Development Plan Document (DPD) Publication Stage Representation Form

Publication Amended Allocations & Development Management Development Plan Document (DPD)

Objection to Site 2 - Transport and Highways Technical Review

SLR Consulting Ltd [SLR] has been instructed by Urban & Civic [U&C] to undertake a technical review of transport and highways matters associated with a potential site allocation for gypsy and traveller pitches.

Figure 1-1 Belvoir Ironworks North Site Location

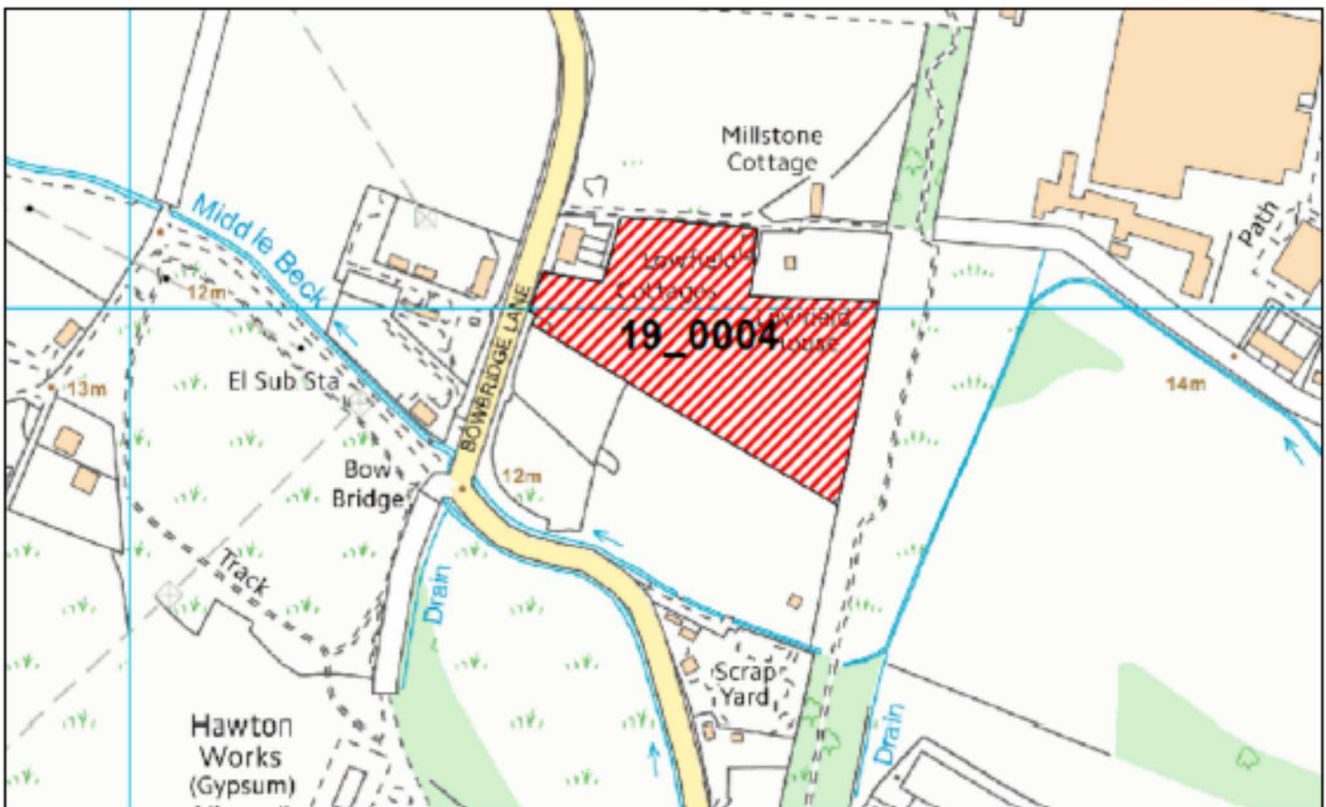
Based on the red line boundary of the site, the only potential access point to a development in this location would be from Bowbridge Lane immediately to the south of a row of terraced residential properties. Part of this site frontage has an existing access to the agricultural field and it is assumed this would be broadly the location required to be utilised to facilitate access to the gypsy and traveller pitches.

Bowbridge Lane adjoining this section of the site frontage is subject to the national speed limit of 60 miles per hour [mph]. A change in speed limit to 30mph does occur approximately 30 metres to the north of the existing agricultural access, however unless it could be demonstrated that speeds are less than 60 kilometres per hour [kmh] / 37 mph, stopping sight distance for the purpose of visibility splays will need to be based on parameters from the Design Manual for Roads and Bridges [DMRB]. This approach is outlined in Section 3.3.1 of the Nottinghamshire Highway Design Guide [NHDG].

Based on these parameters, the minimum “Y distance” for a visibility splay from a proposed access to this site in this location would be 120 metres if it could be demonstrated that 85th percentile speeds were 70 kph / 43 mph. Given that the road is subject to a 60mph speed limit, however, the starting point for stopping sight distance based on this design speed would be 215 metres.

Taking the above into consideration, and based on the horizontal alignment of Bowbridge Lane in the vicinity of the site and the presence of what is assumed to be third party land, it is clear that 215 metres could not be achieved for either forward visibility on Bowbridge Lane or for the site access visibility from an “X-distance” of 2.4 metres. Given also that horizontal bends in the alignment of Bowbridge Lane are located approximately 120 metres to the south of the existing agricultural access and less than 120 metres to the north of this, it is also unclear as to whether the lowest level of visibility¹ could be achieved for any site access design in this location.

Taking the above into consideration, it should be noted that the Belvoir Ironworks North site would be:

- In excess of an 800 metres walk to the nearest local facilities at Middlebeck, such as the primary school, and to other local facilities in the south Newark and Balderton areas; and
- In excess of an 800 metres walk to the nearest future bus stop on Marleston Lane at the Middlebeck SUE and to the existing bus stops on Grange Road to the north of Middlebeck.

When being assessed against accessibility criteria at the heart of both the NPPF and the NHDG, therefore, this site cannot be considered as sustainable for development from a transport perspective.

- It is unclear based on the information available as to whether a safe and suitable access to the site can be achieved for the proposed use in visibility terms;

- Based on the potential level of trip generation associated with the use, there may be a requirement for the access to the site to include a central treatment on Bowbridge Lane (such as a ghost island right turn). No information is available to demonstrate that such a junction arrangement would be deliverable within land controlled by the local highway authority and that associated with the site;

Urban & Civic respectfully request that proposed Gypsy, Roma and Traveller pitches at the Former Belvoir Ironworks are removed from the AADMDPD. As such, Urban & Civic respectfully request that Site NUA/GRT/13 Former Belvoir Ironworks, Bowbridge Lane, Newark is deleted from Policy GRT4 (Site Allocations) and removed from the Policies Map (Map 2 Newark South Proposals).
